## **Addendum No. 1**

To:  
New Community Building  
Trumann Housing Authority  
Trumann, AR  
April 16, 2024

The Plan holder's attention is hereby directed to the following changes in the drawings and specifications.

1B EXTERIOR WALL SECTION AT TORNADO SHELTER  
 SCALE: 3/4" = 1'-0"

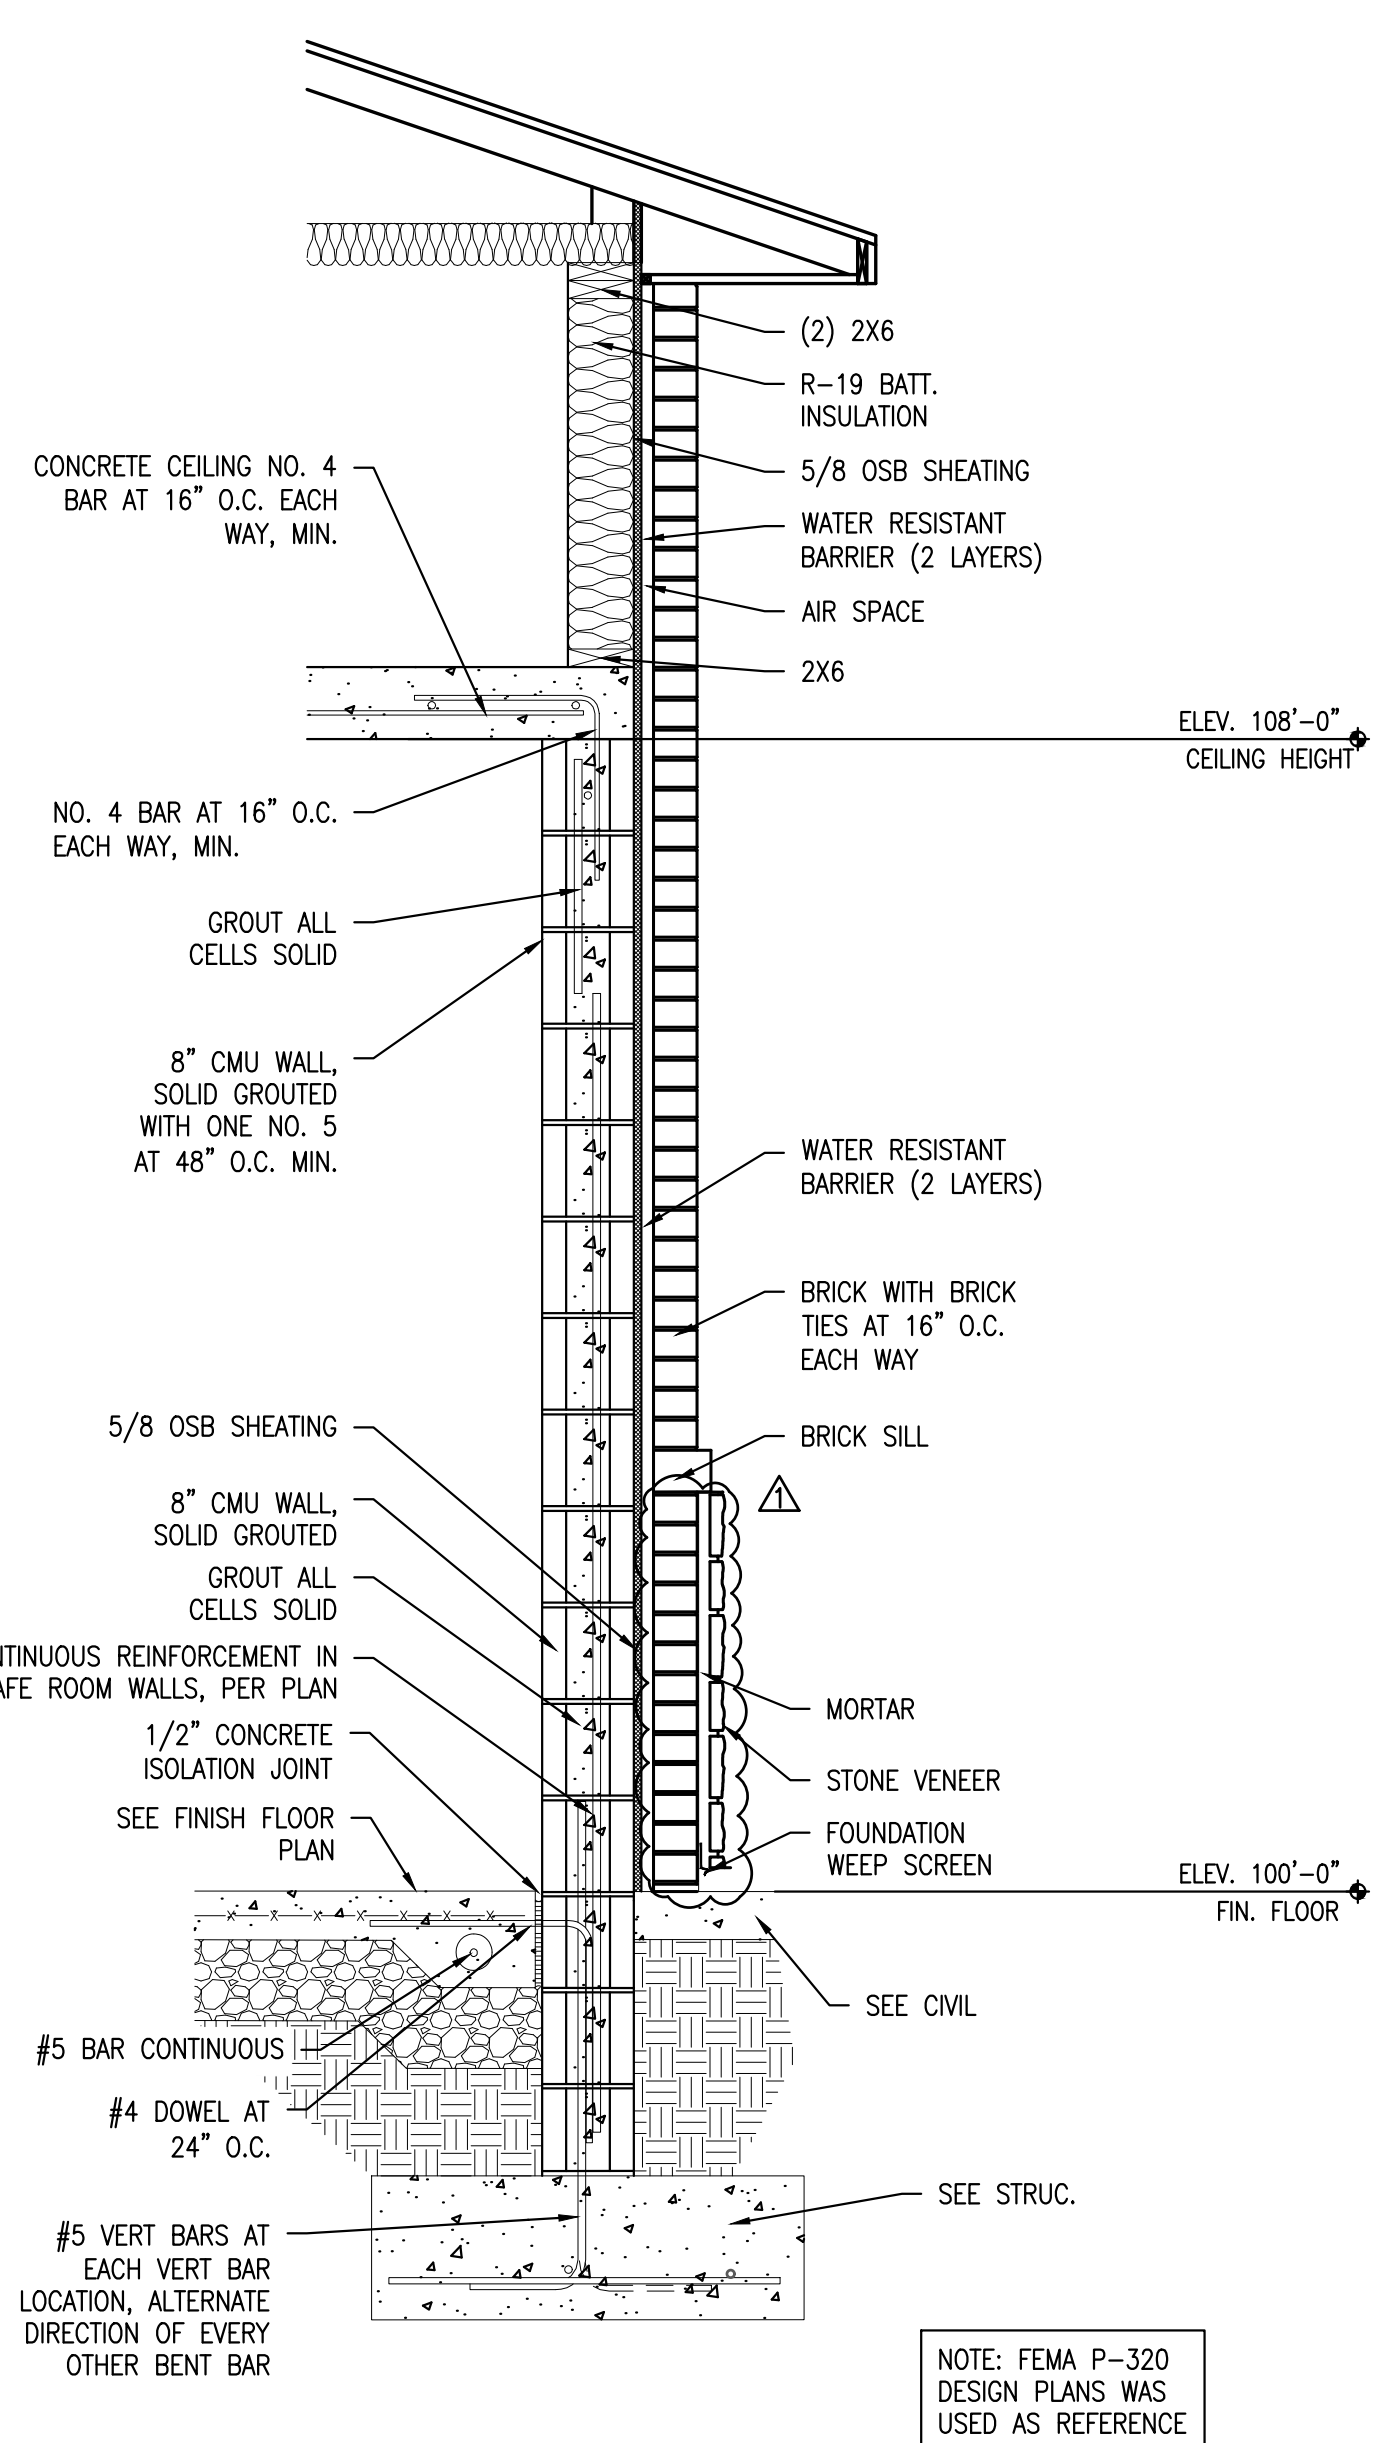
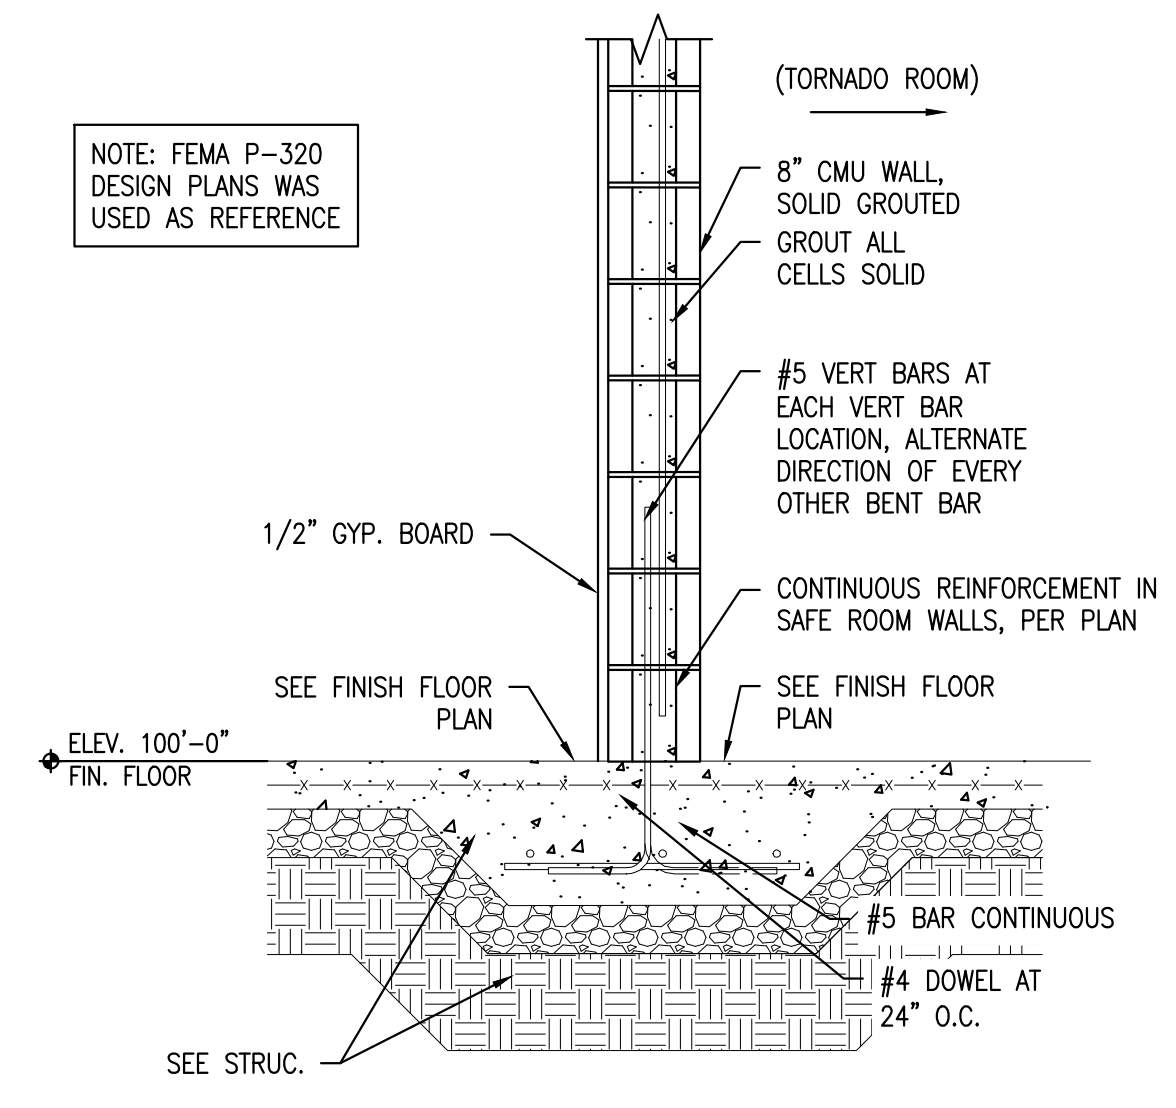
- Item No. 1:** **Revised Drawing:** Stone and Brick Masonry Wall Detail (Revised detail 1A/A-05.1 and 1B/ A-05.2 attached). Contractor may utilize different methods of masonry support for the stone veneer/brick wall with Architect's approval.

- Item No. 9:**     **Clarification:** Insulation R-Values are to be R-19 Batt for the walls and R-38 Blown for ceiling.
- Item No. 10:**   **Clarification:** Tornado shelter ceiling is concrete (Sheet A-05.2 / Detail 1B)

**1 SITE PLAN - ELECTRICAL**  
 E0.1 1/16" = 1'-0"

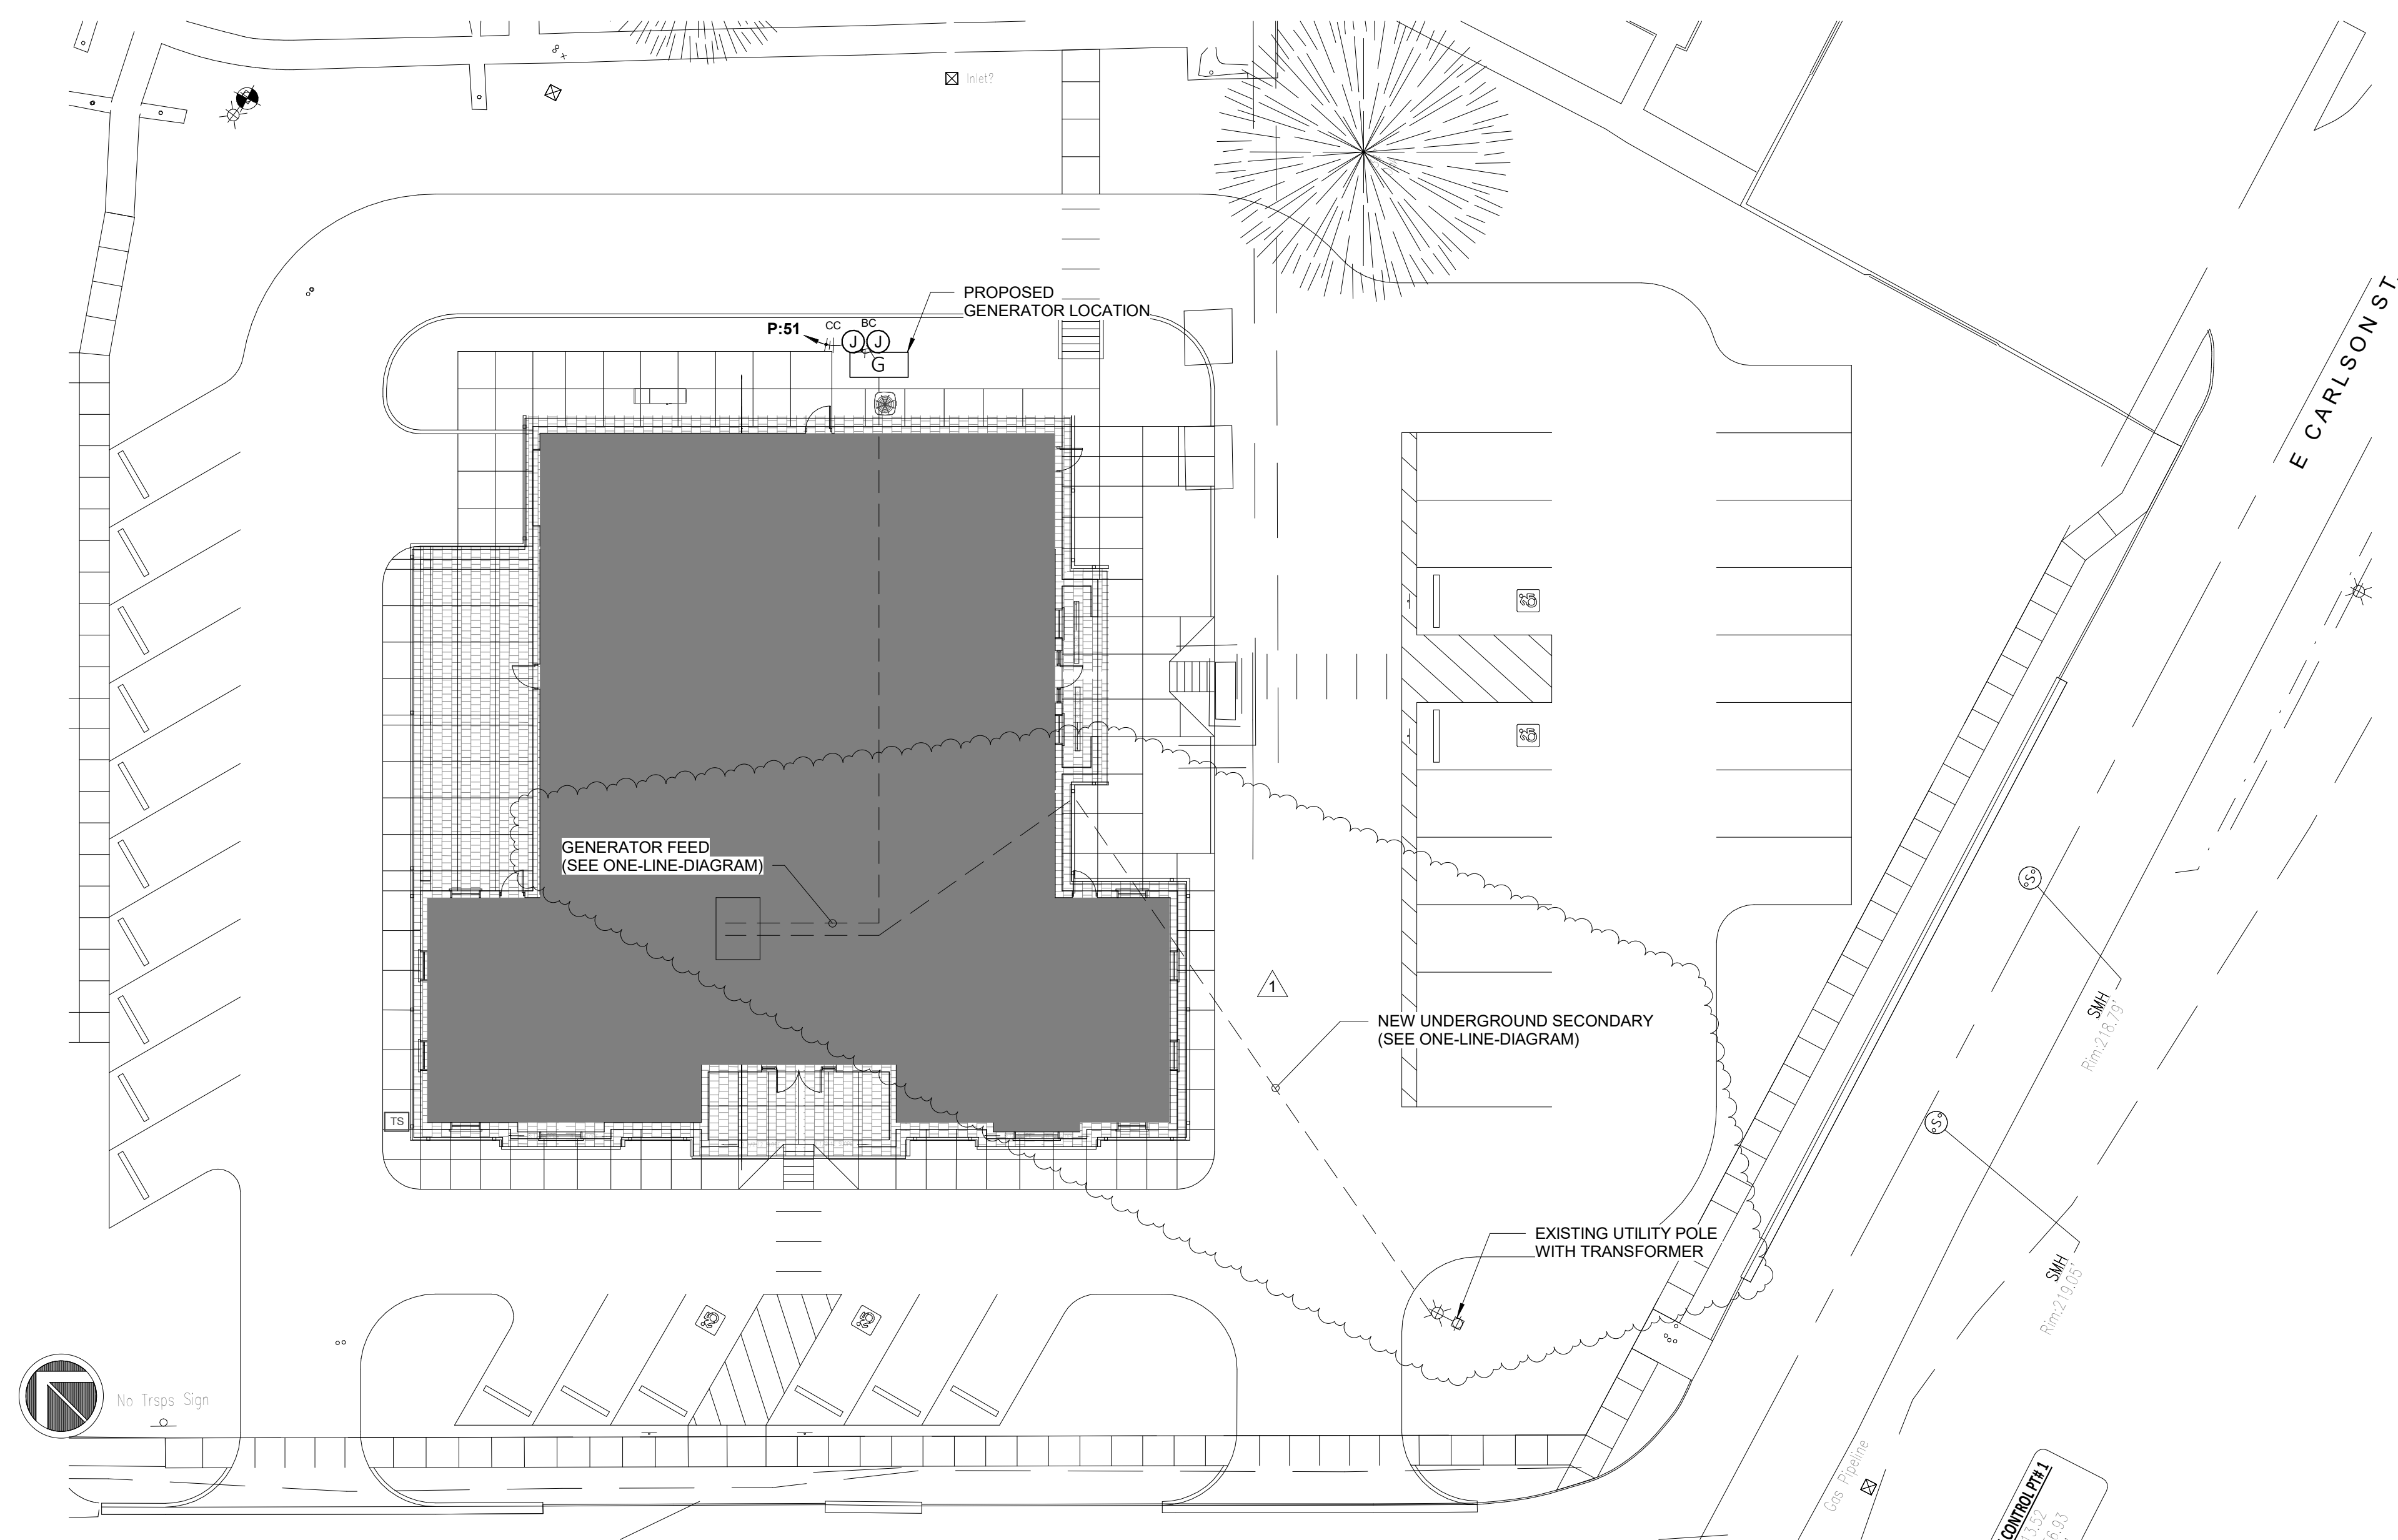
- Item No. 7:** **Revised Drawing:** Electrical Update to outside means of disconnect. (See Attached). Revise the electrical service entrance to provide a fusible disconnect on the building exterior and revise panel P from a main circuit breaker to main lugs only style panel. Refer to updated drawings for location of fusible disconnect.
